STATE OF NORTH CAROLINA
DEPARTMENT OF TRANSPORTATION

Addendum No. 1
RE: Contract # C204039
WBS # 34243.3.2
STATE FUNDED
Polk County (I-4729A)
I-26/US-74/NC-108 Interchange Modifications in the Town Of Columbus

September 19, 2017 Letting

The following revisions have been made to the Roadway plans:

17-AUG-2017 10:15
J:\I-4729A\Roadway\XSC\I-4729A_Rdy_xpl.dgn
$$$$USERNAME$$$$

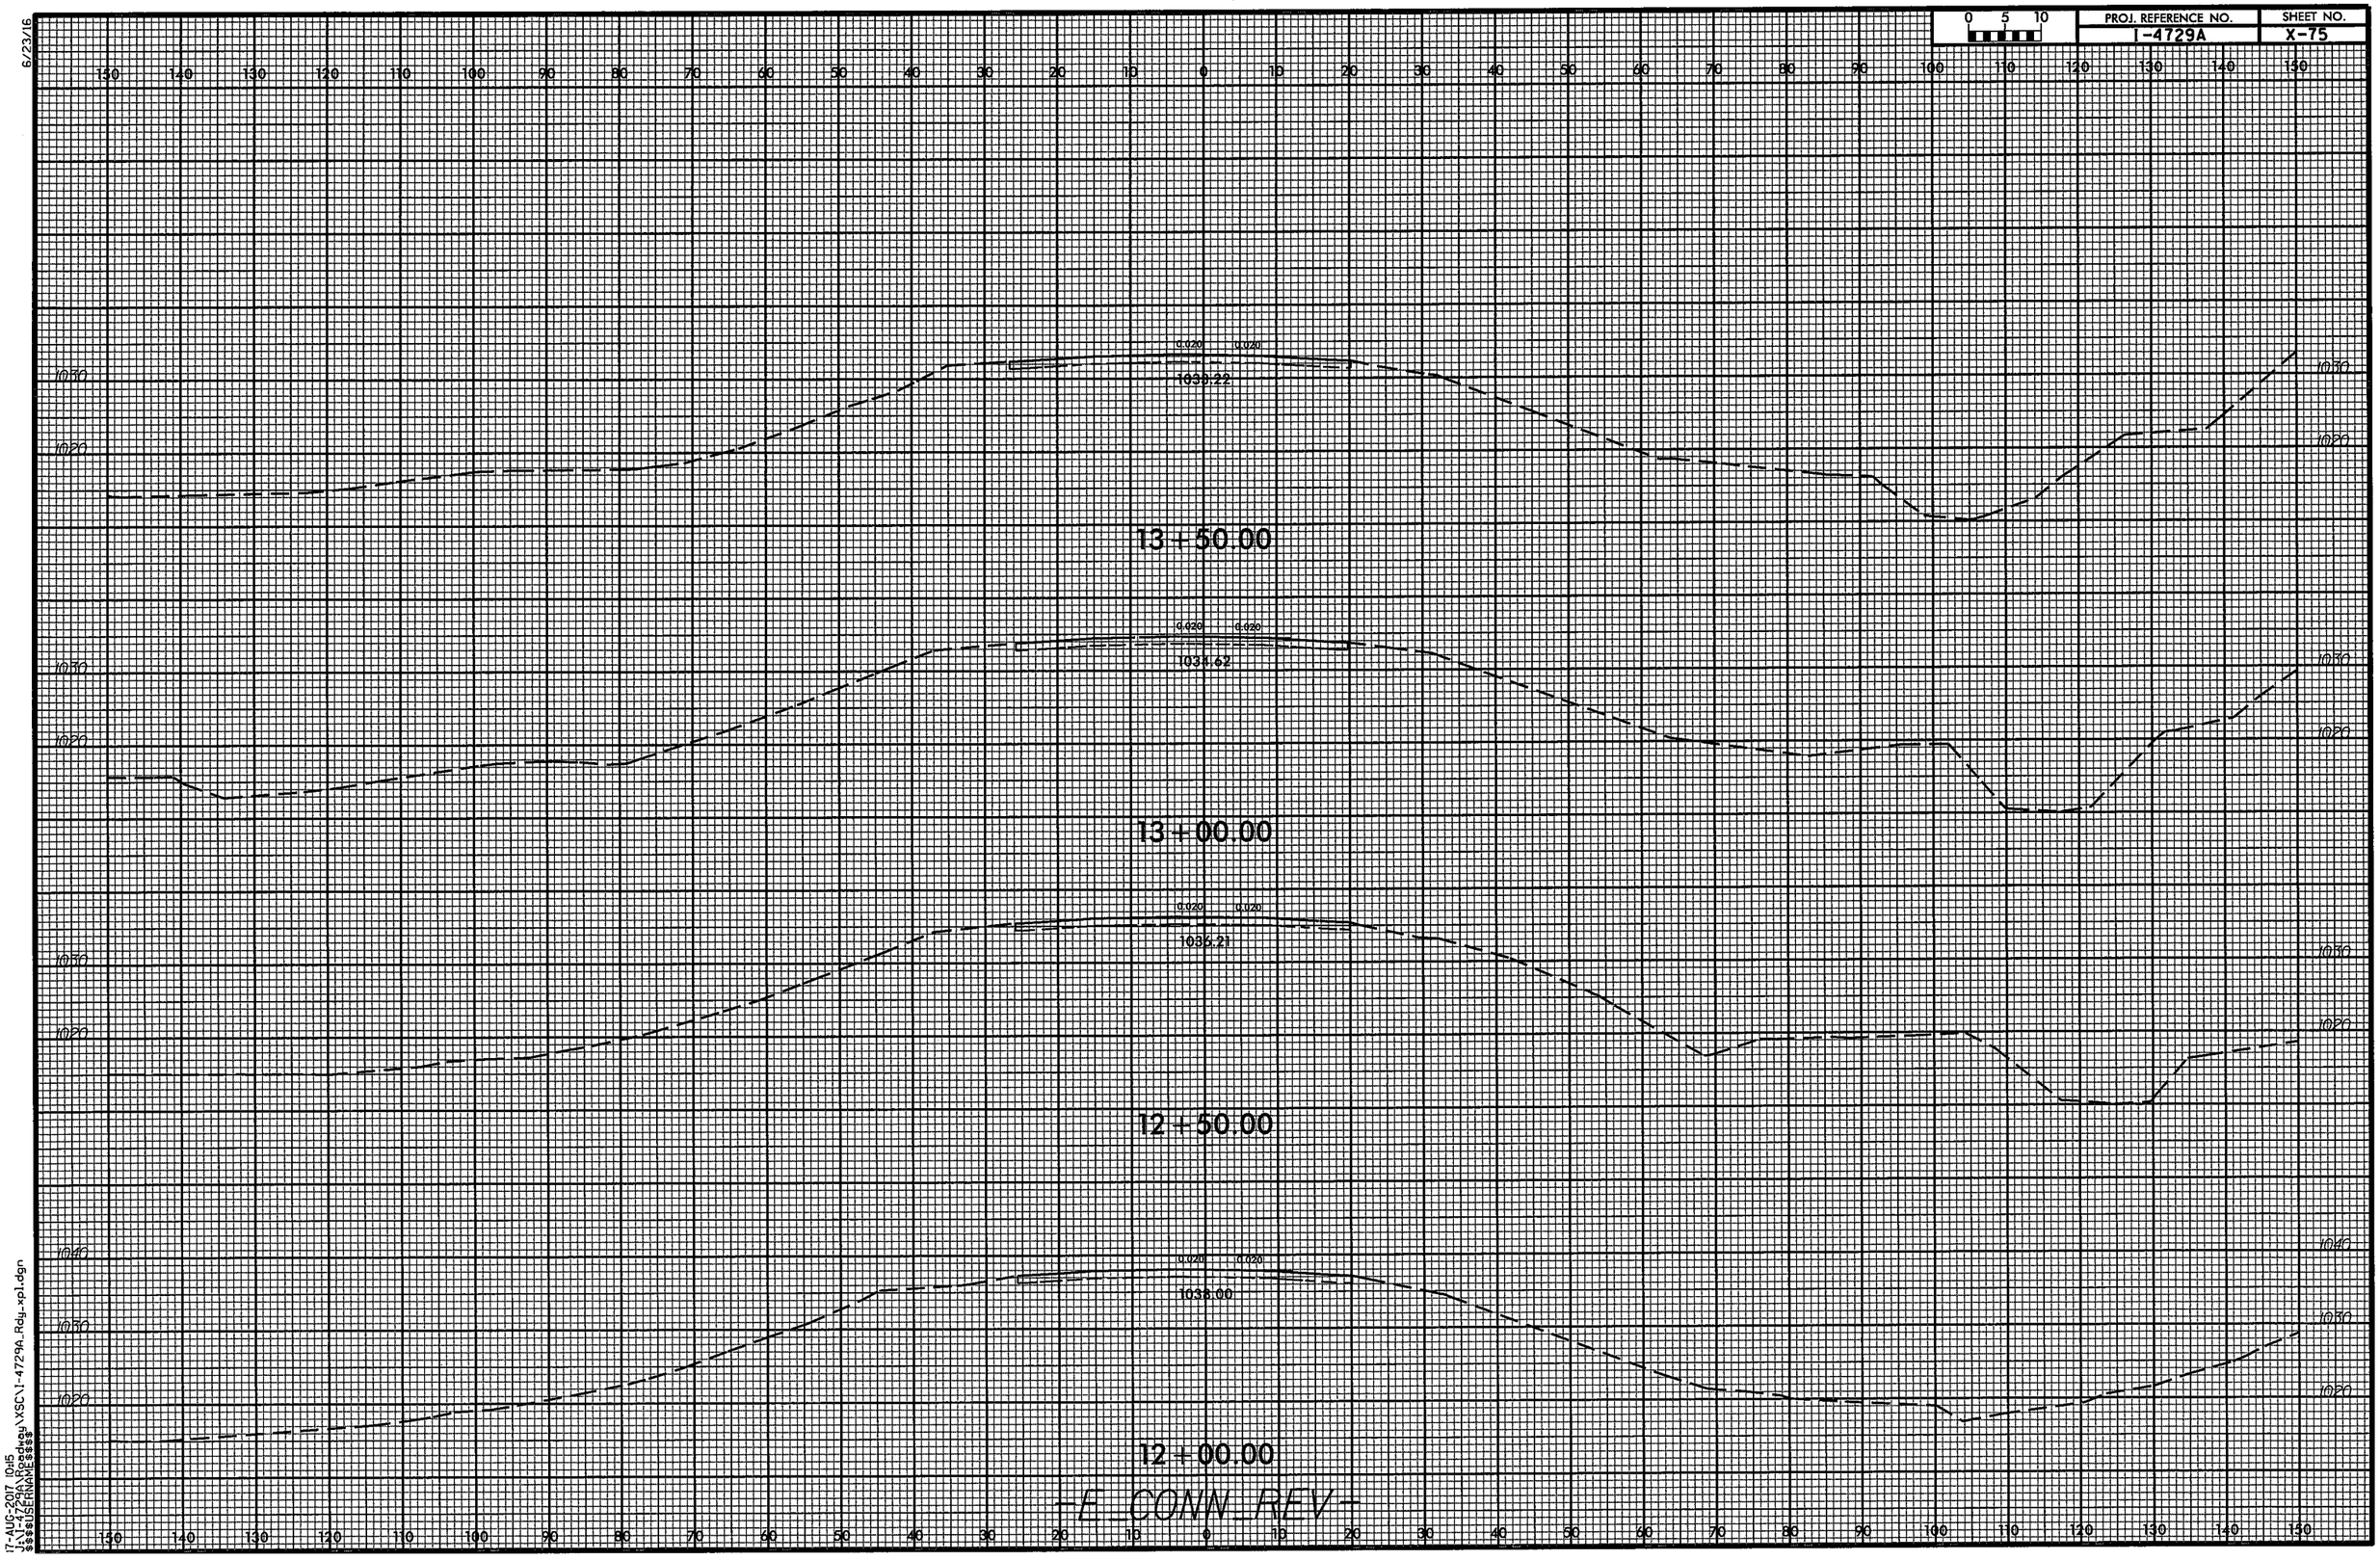
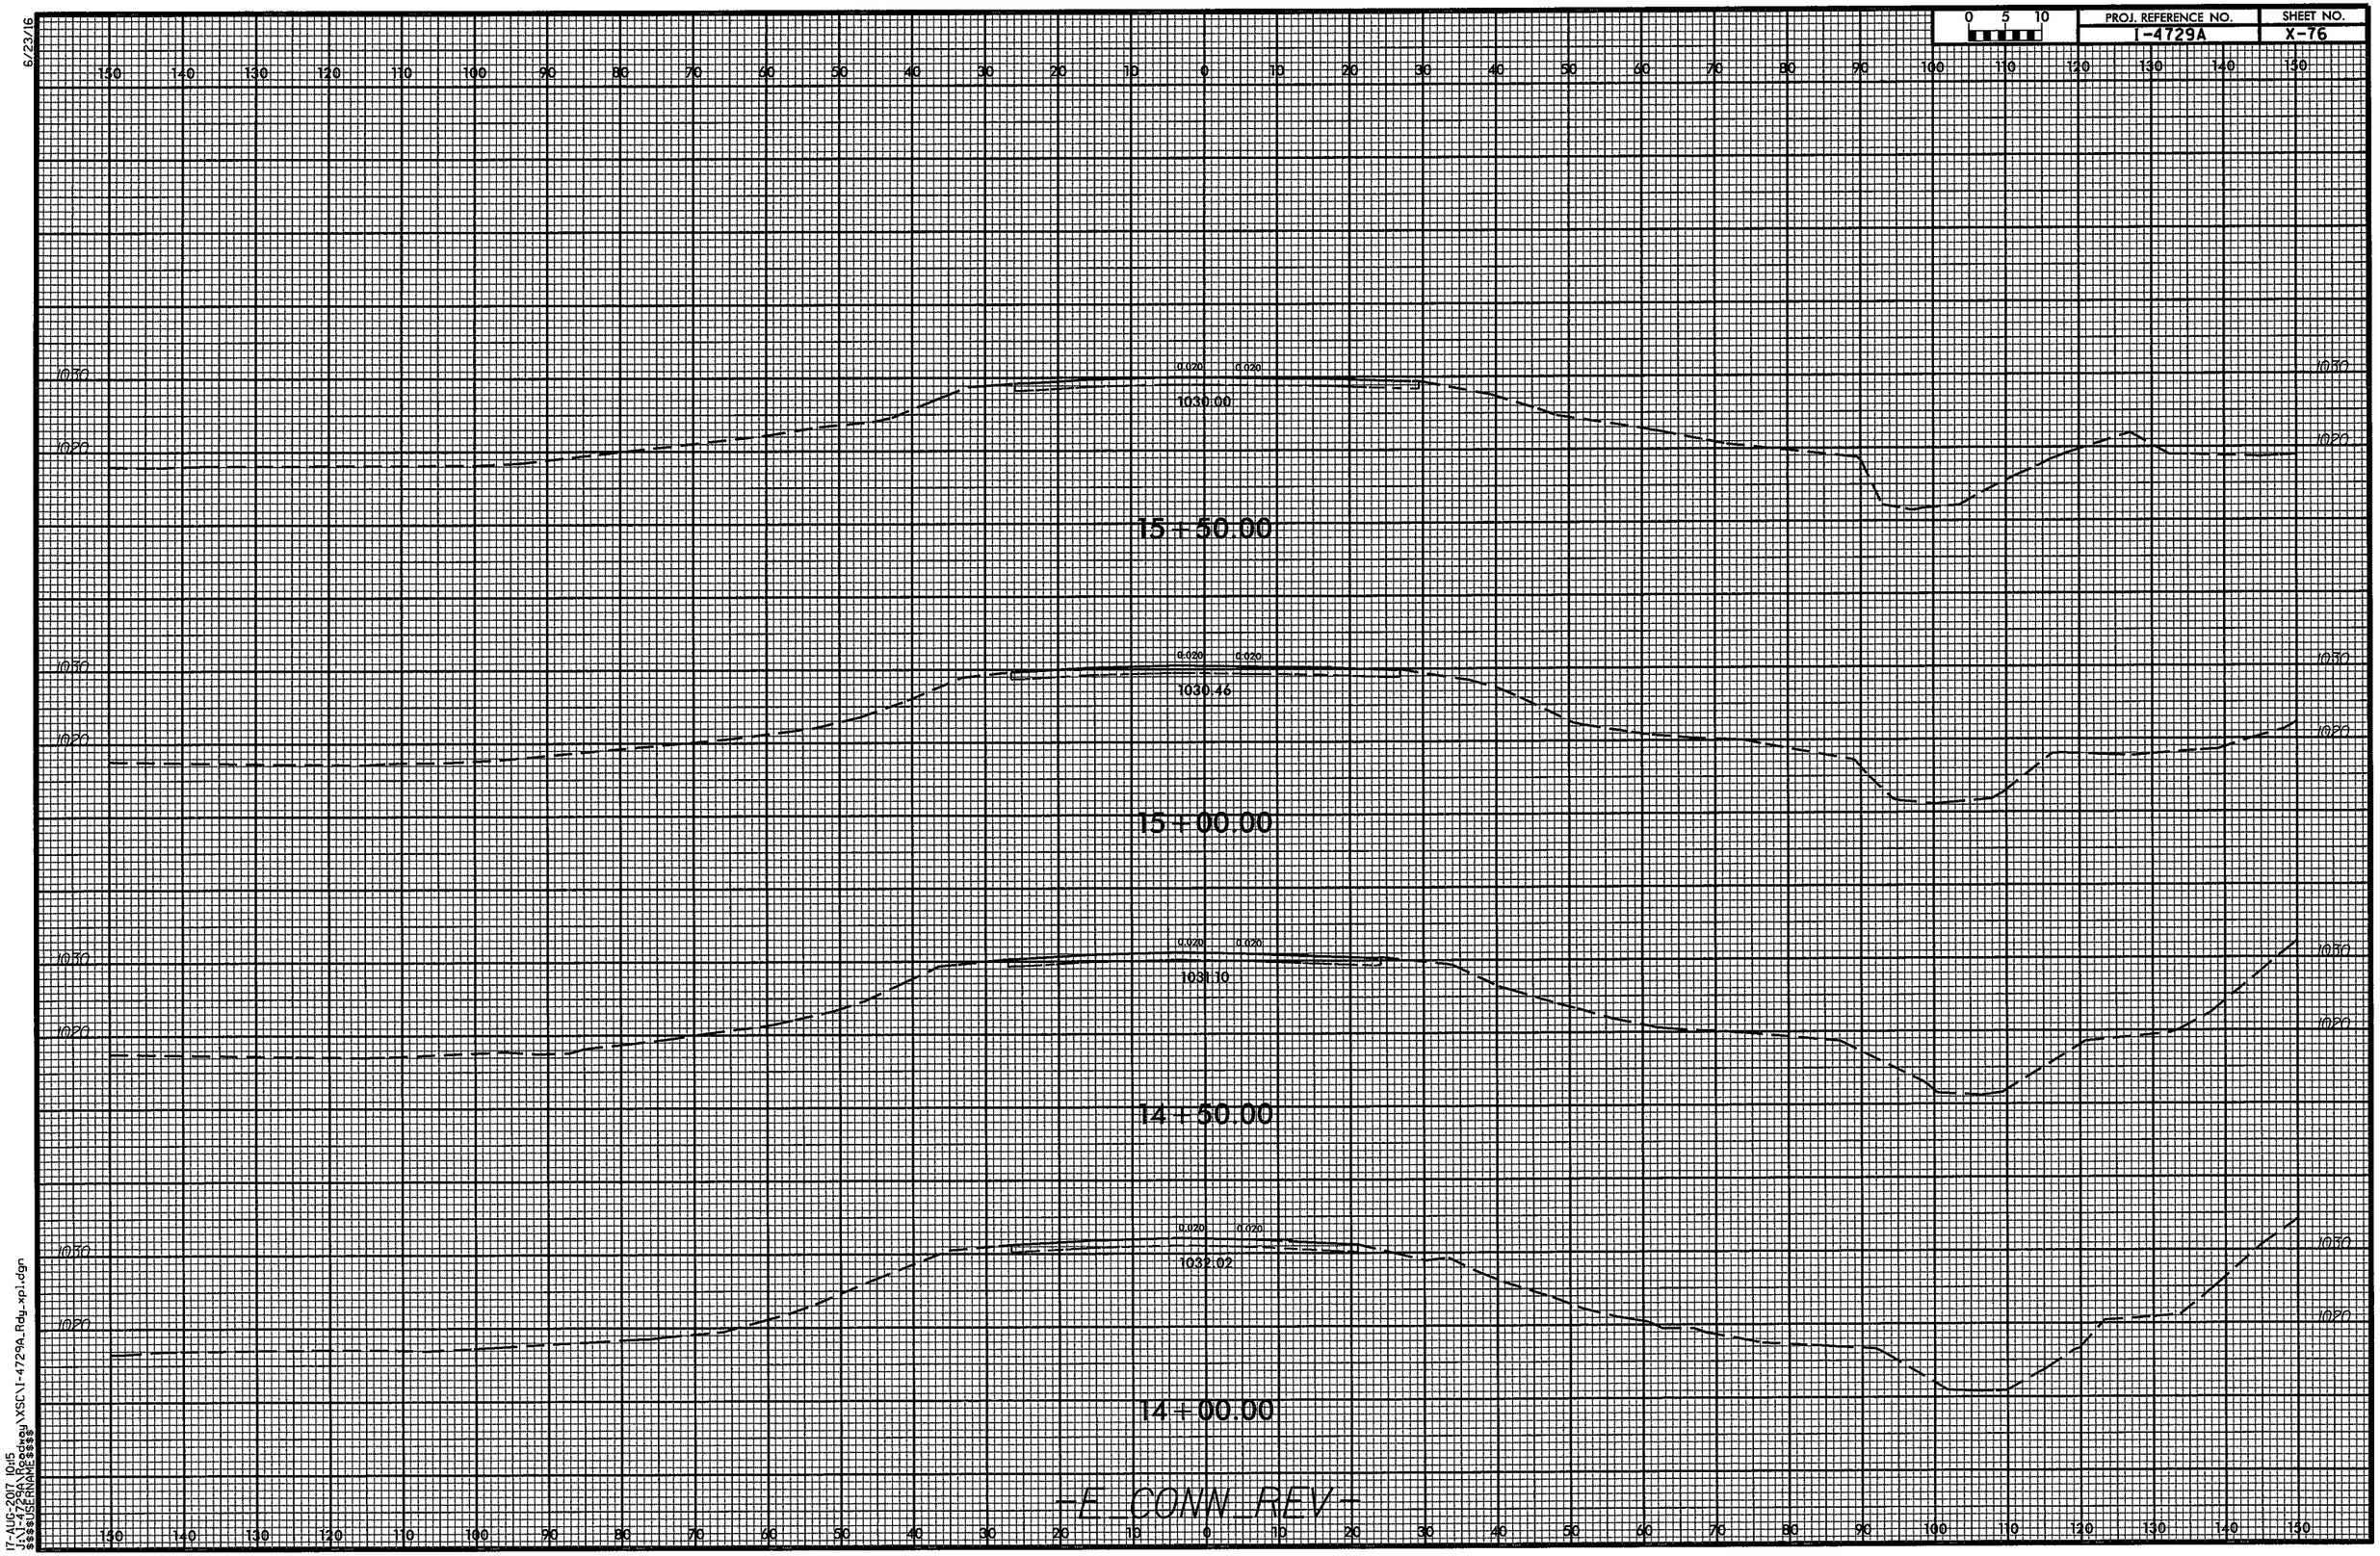
Sheet No.	Revisions
1A	Revised Index of Sheets to remove 2G-2 "Standard Embankment Monitoring Detail" and revise the number of" Drainage Summaries" sheets
2A-1, 2A-4 and 2A-5	Revised the Typical Sections for the change in mainline pavement widening design from ABC to Asphalt Base
3B-1	Revised 'Summary of Earthwork' to account for pavement widening design change
3D-1 thru 3D-4	Various drainage quantity changes as noted below
3G-1	Removed "Settlement Gauge Summary" and added note that Bridge Waiting Period only applies to Approach Slab construction
5	Revised to require Welded Steel Pipe by Trenchless method under the Interstate 26
X-1A thru X-87	Revised Cross-Sections to reflect the change in Earthwork due to the pavement design change
